April 26, 2019

Mr. Elliott R. Russell, Environmental Protection Specialist — DRMS

MineWater Finance LLC (MineWater) received your Notice of Deficiencies for Modification MD-03 for File No. P-2016-020 dated April 15, 2019. Thank you for your detailed review and response. MineWater is pleased to provide this response to the points raised in the Notice, as follows:

Figure 1: Plan view map of multi-lateral borehole installed with HDPE or FPVC liner to 3,000 ft.

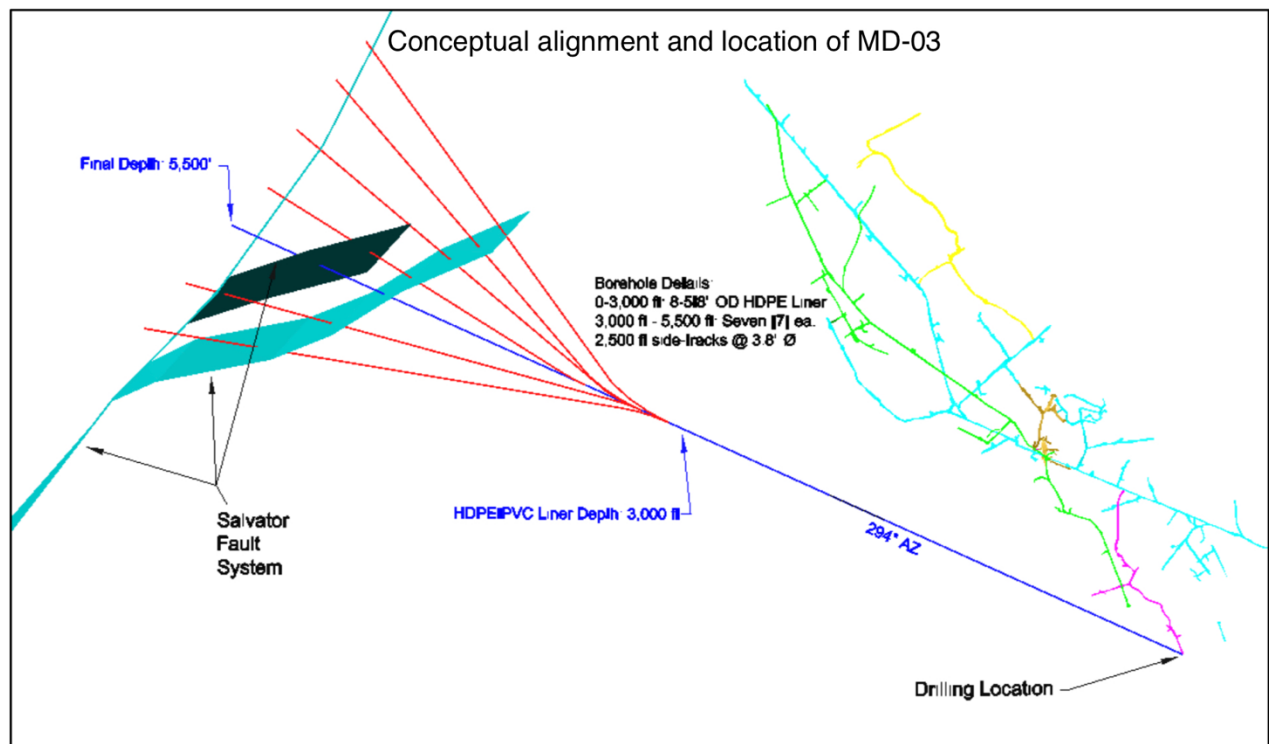
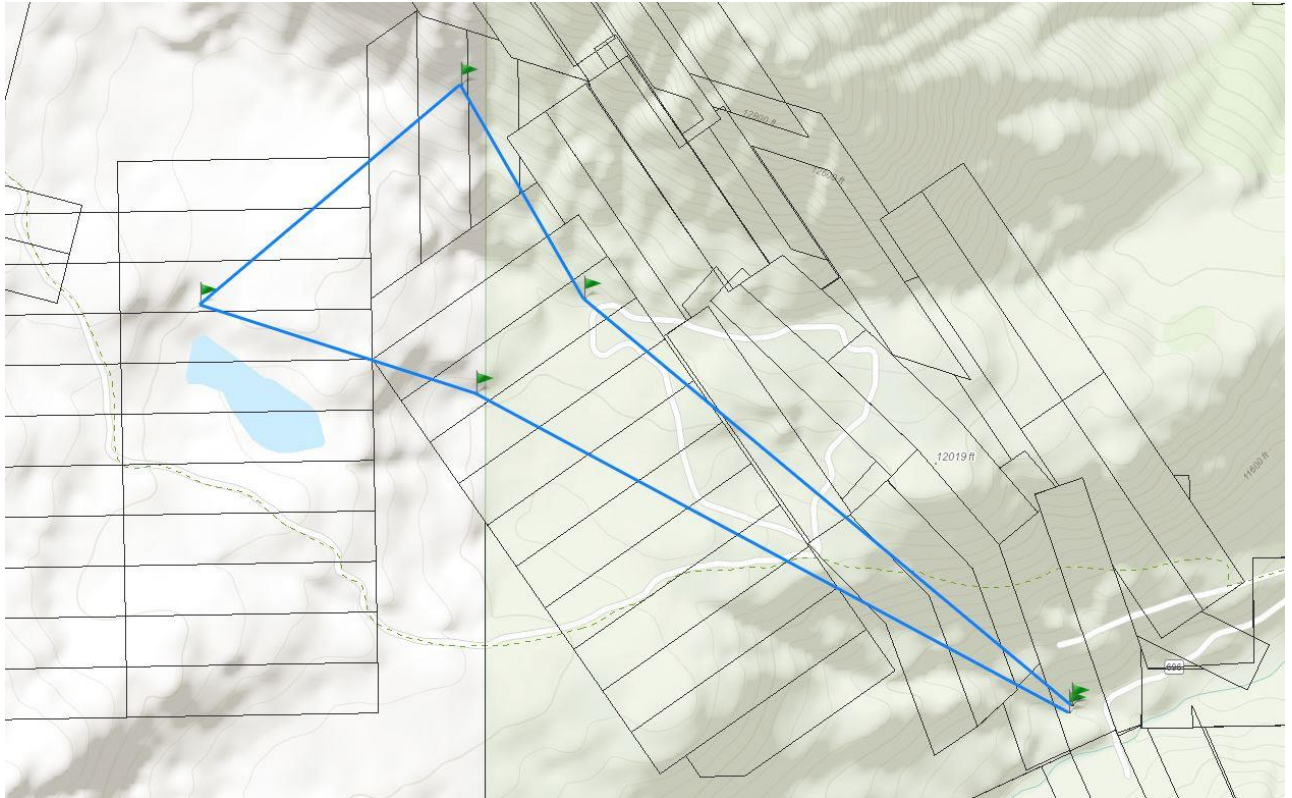
1. MineWater hereby withdraws Form 1; it was our intention that Form 1 and Form 2 were to be duplicates.
2. The topographic location of the drill hole is collared within 50 feet of the Ophir Tunnel and the previously drilled LM-2.5; as shown in reference to the existing mine workings map

The fan alignment shown is for example-only and will be field optimized based on rock hardness, fracturing and faulting, and retargeted based on recovered mineral values in the pilot hole and subsequent side tracks (pilot shown in blue). We will be testing generally vertically oriented

mineralization in and near the Salvator fault system and assaying for metallurgical constituents to guide location of the fan elements.

Topography and alignment of the main access borehole and the fan at the end of the access boring with respect to our land ownership is depicted on the following image developed using Park County GIS tools:
